CONSTANT-LENGTH ROTARY COLLAR / NON-ACCEPTED CANDIDATE

Stationary core Ø48 × 142 mm; trial shell Ø66 mm; ±90° geometric paths. No assembled mechanism acceptance.

AXIAL SECTION — X along core; radial section at USB. Board bay shifted +1.8 mm past fixed stop.

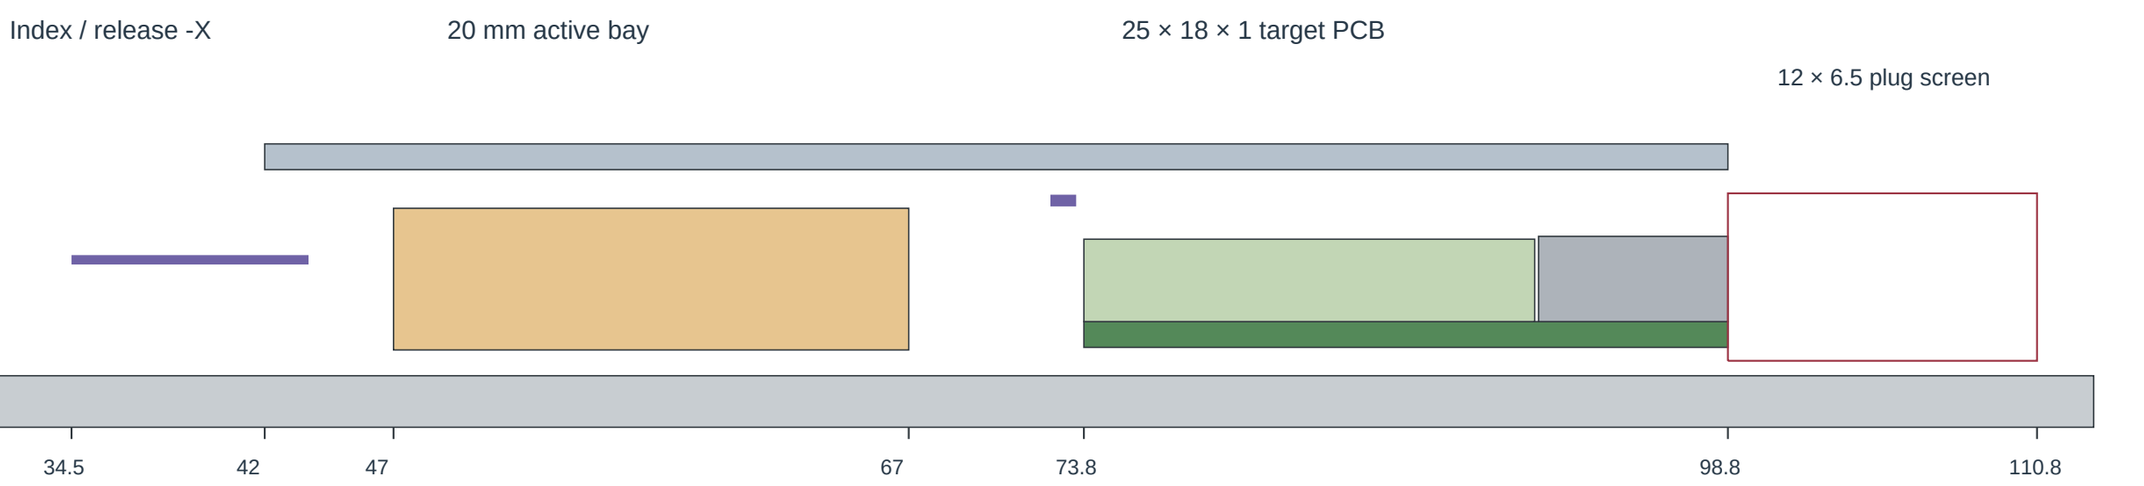
X / mm (11 drawing units/mm). Core continues X0..142; complete stationary connector endcaps not represented.

FIXED-TAIL CLAMP COMPLETION FAIL

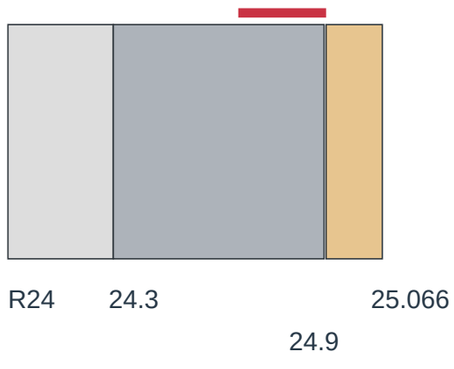
150 drawing units/mm; proposed stiffener + gap shown in red.

Only 0.005676 mm behind fixed tail; 0.20 mm stiffener + 0.05 gap needs another 0.244324 mm.

CAD also retains unfinished retention passages and a disconnected backing island.
